Subject: Response to Review Comments
Preliminary Geotechnical Investigation
Proposed Pacific Center Development
1071 N. Tustin Ave., 1065 Pacific Center Dr., and 1041 W. Pacific Center Dr.,
Anaheim, California

1. Anaheim 2017. *Geotechnical Engineering Review Sheet, City of Anaheim, Plan Check #OTH 2017-00946*, Albus-Keefe & Associates, AKA Project Number 2608.0, April 26, 2017.
2. NOVA 2017. *Report, Preliminary Geotechnical Investigation, Proposed Pacific Center Development, Anaheim, California*, NOVA Services, Inc., February 17, 2017.

Figure 1. Estimates of Seismic Settlement for Average CPT Data and Groundwater Levels At 10 Feet, 35 Feet and 50 Feet Below Ground Surface

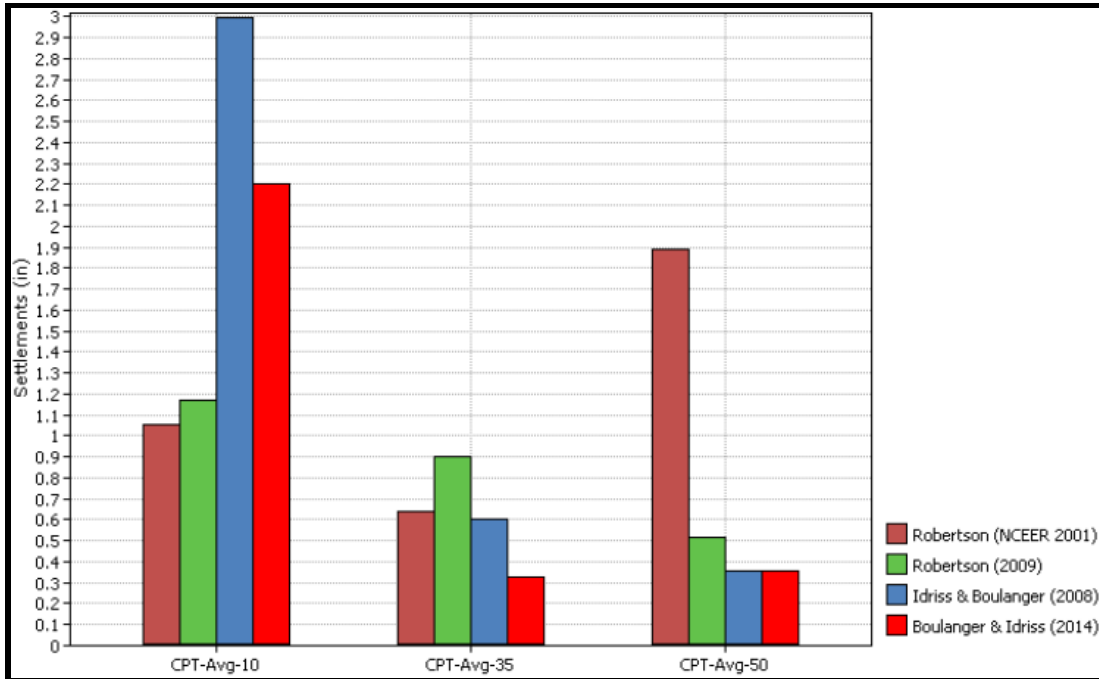
Comment 3, Groundwater Level for Analysis. *Groundwater depth of 35 feet is used in liquefaction analysis. According to Seismic Hazard Zone Report 011 (Orange 7.5-Minute Quadrangle, 1997), in the area of the project the historically high groundwater level is estimated as shallow as approximately 10 feet below the ground surface. Please provide the reasoning and data to support the assumed groundwater depth of 35 feet. Otherwise, liquefaction potential should be re-evaluated with consideration of the historic high ground water levels, followed by the associated seismic settlement and lateral spread.*

Liquefaction analyses have been reconsidered using an assumed groundwater level of 10 feet bgs. Records of this evaluation are provided as Attachment 2 to this letter. The analyses employed procedures developed by Robertson (2009), available by the software CLiq. Figure 1 and Figure 2 (following page) provides the indications of the re-evaluation of liquefaction.

As may be seen by review of Figure 1, if groundwater levels rise to about 10 feet bgs, the Robertson method indicates that liquefaction and related dry sand movement will be on the order of 1 inch. As may be seen by review of Figure 2, the potential for liquefaction at this site is low if groundwater does not rise to within about 10 feet bgs. However, if the groundwater level rises to about 10 feet bgs, it is likely liquefaction will occur.

NOVA considers it improbable that groundwater levels will rise to within 10 feet of the ground surface in the lives of the planned structures. If this level must be considered by design, NOVA will reissue its report recommending alternative foundation solutions to the shallow foundations described in NOVA 2017.

SUMMARY
OF
CONE PENETRATION TEST DATA

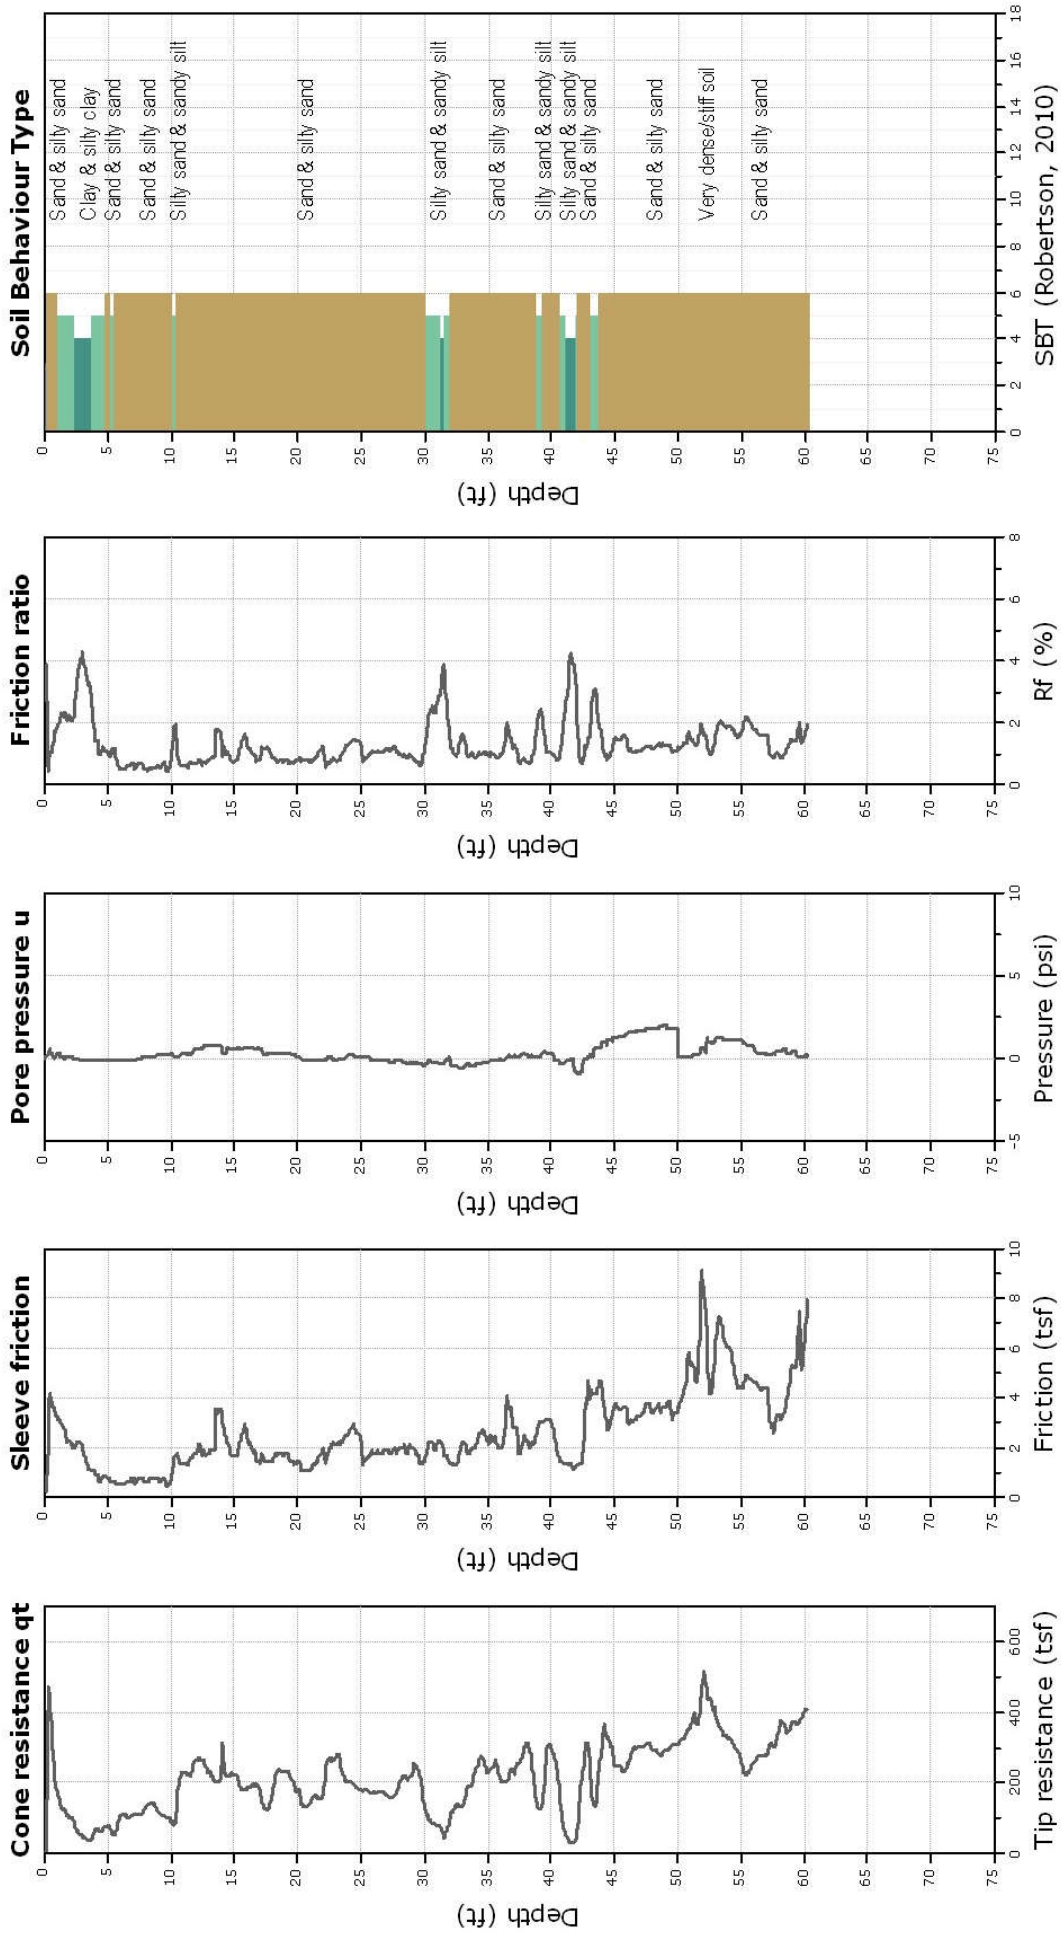
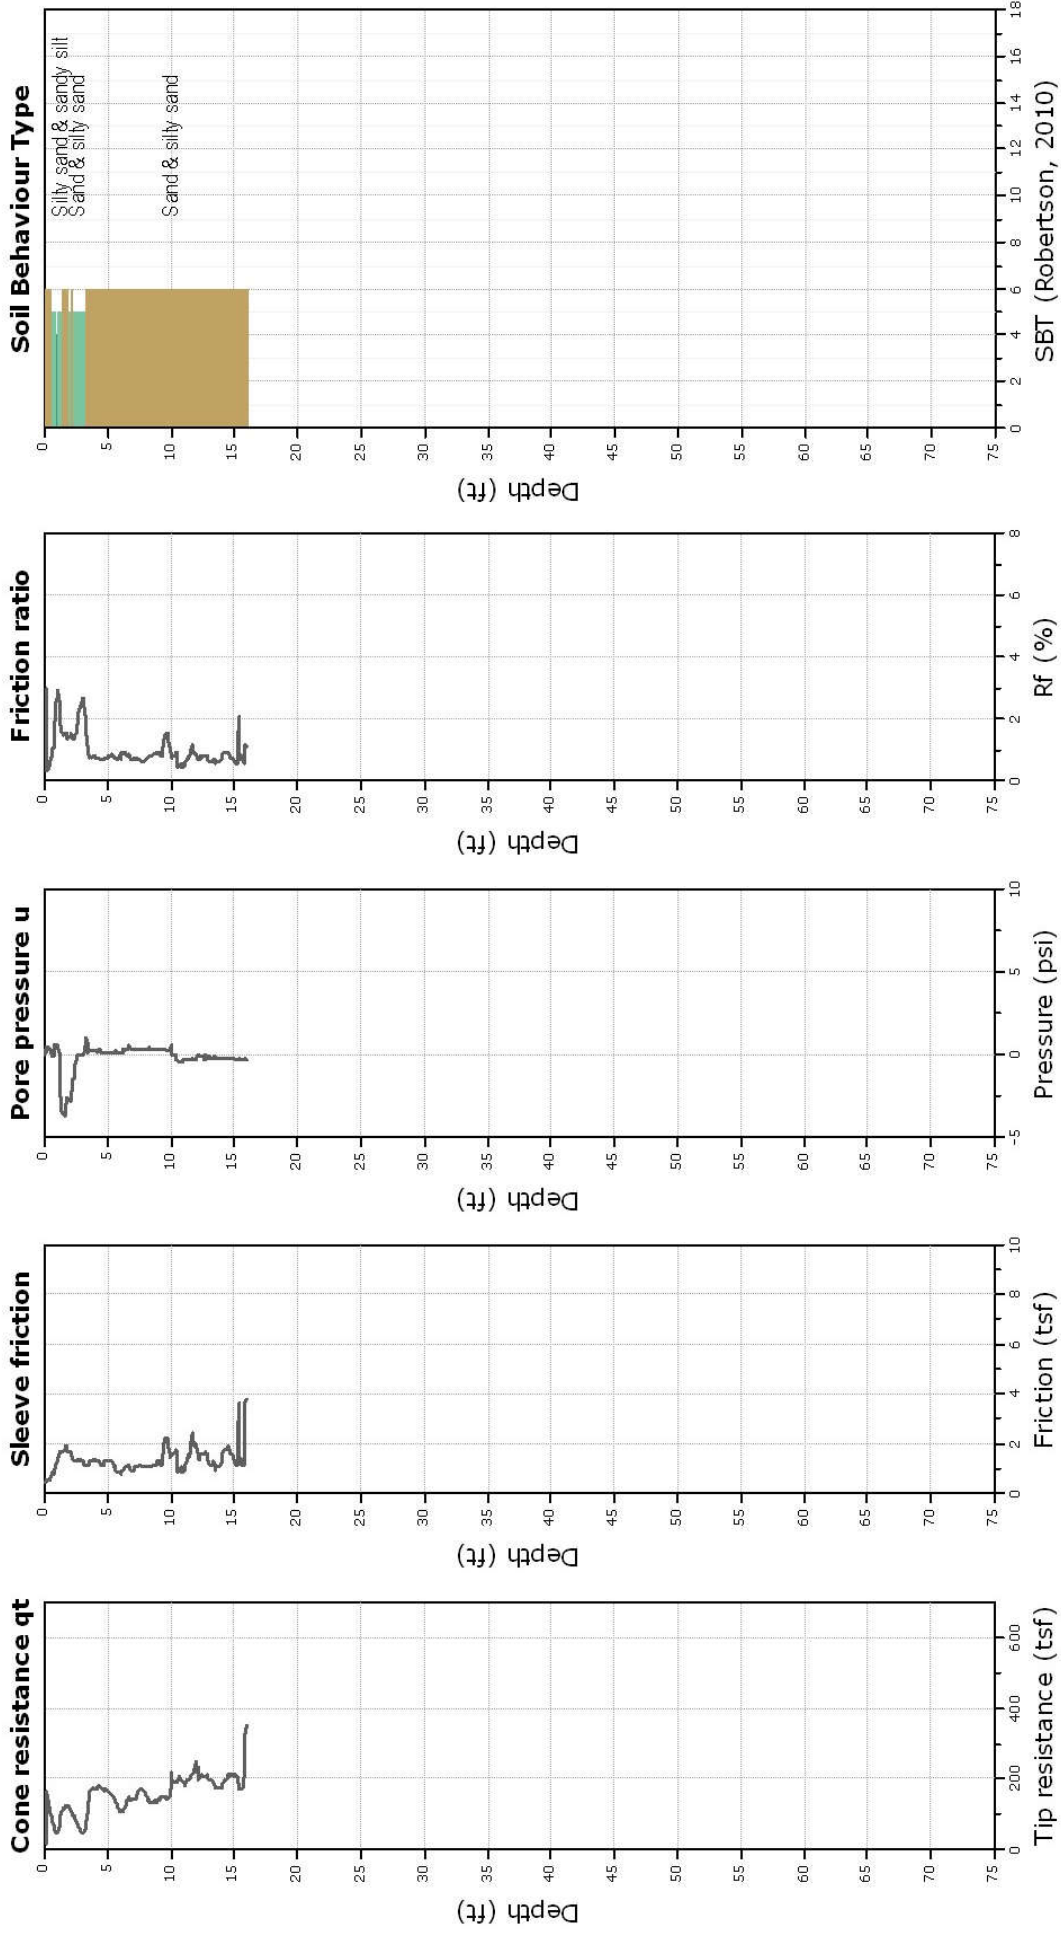
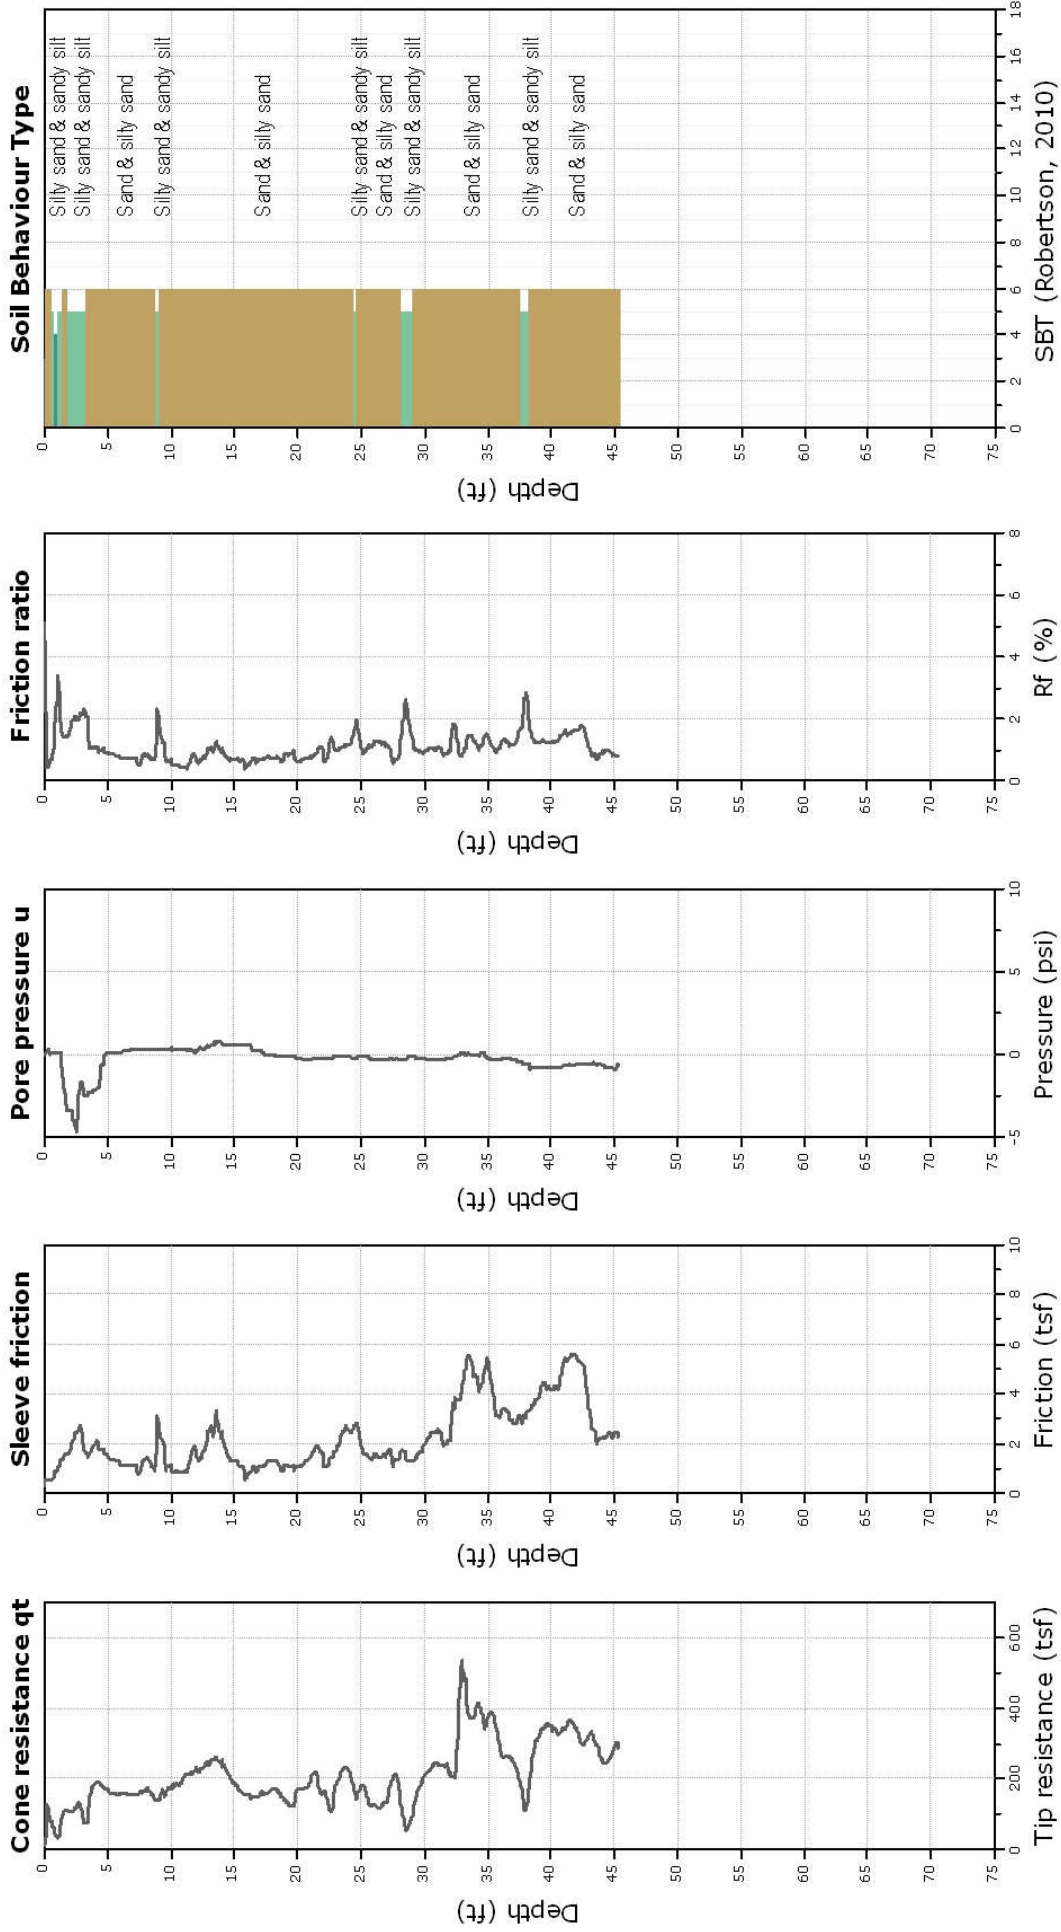
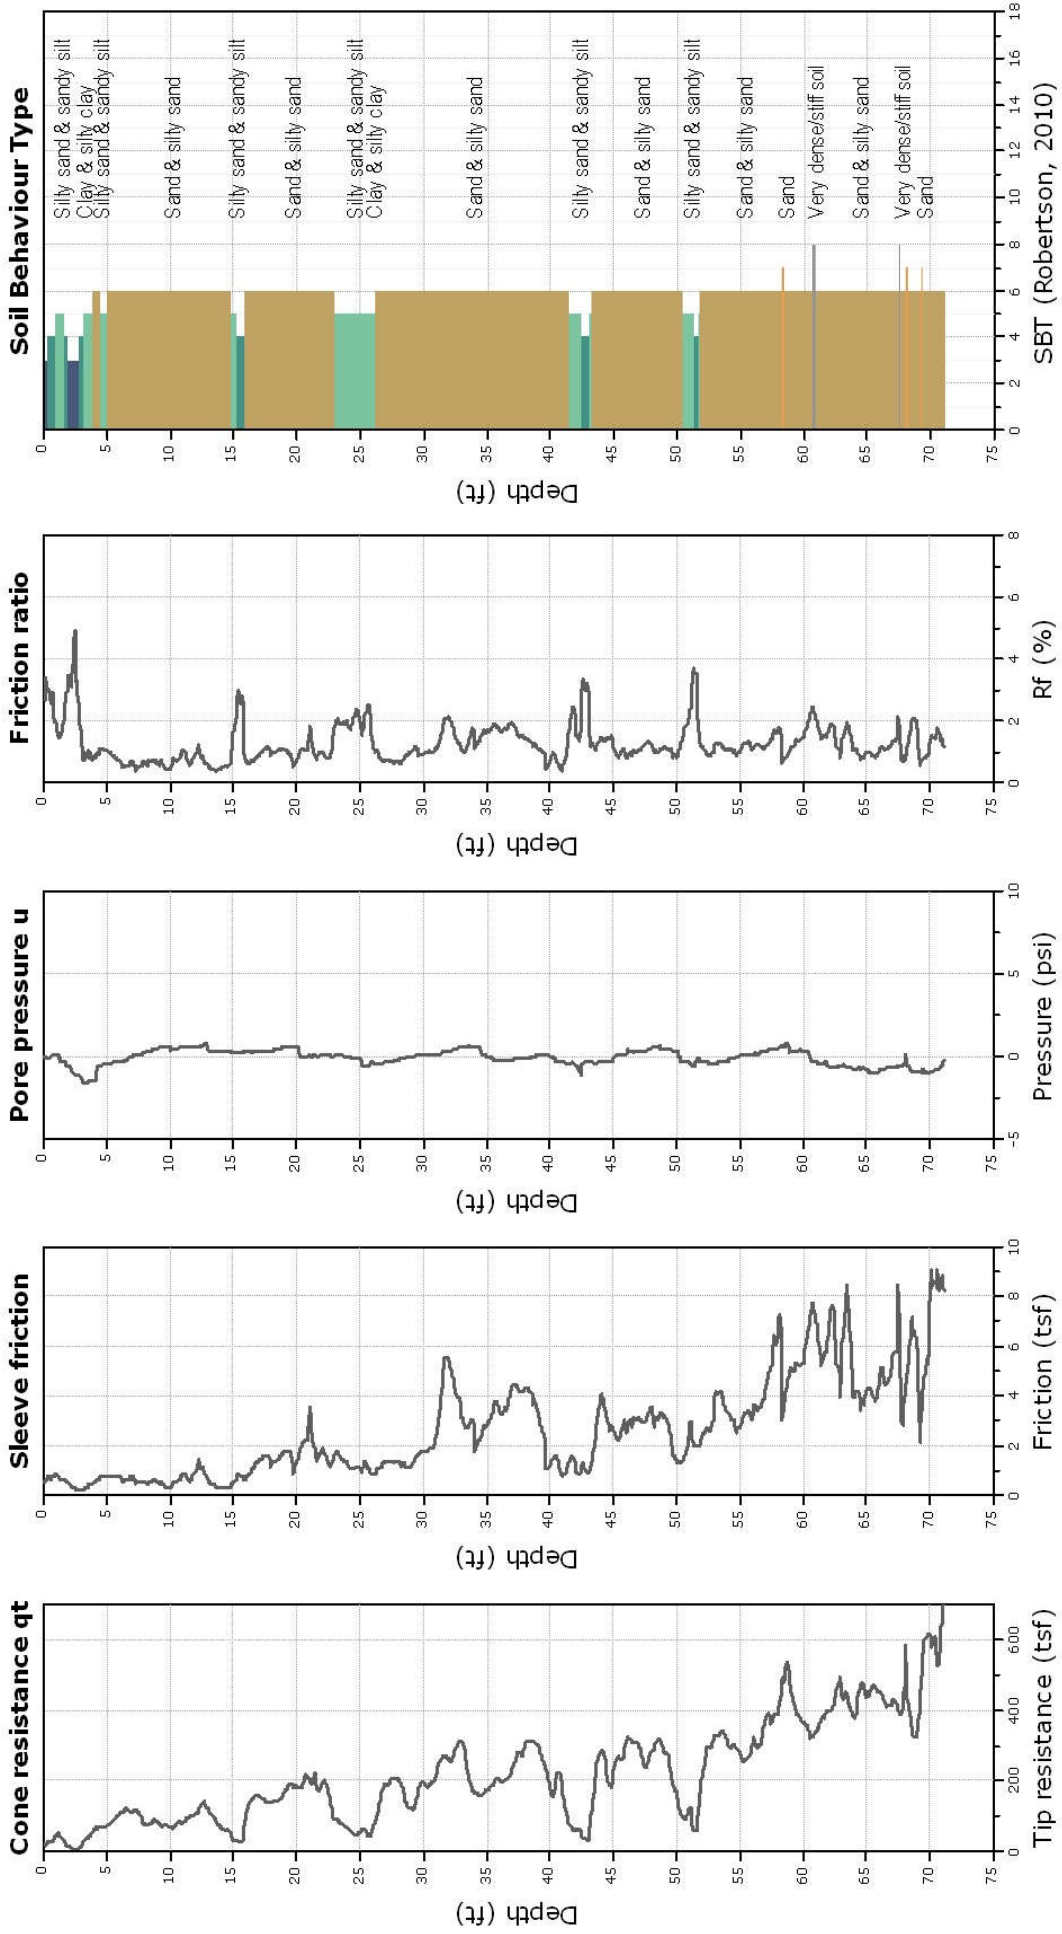
Comment 1, CPT Data. *Section 1.4 (and a few other sections) state that Cone Penetration Test (CPT) data were provided in Appendix C. We could not find CPT data in this or other appendices. Please provide CPT data.*

Response 1. Attachment 1 to this letter provides *Summary of Cone Penetration Test Data* by Kehoe Testing and Engineering, dated January 14, 2017.
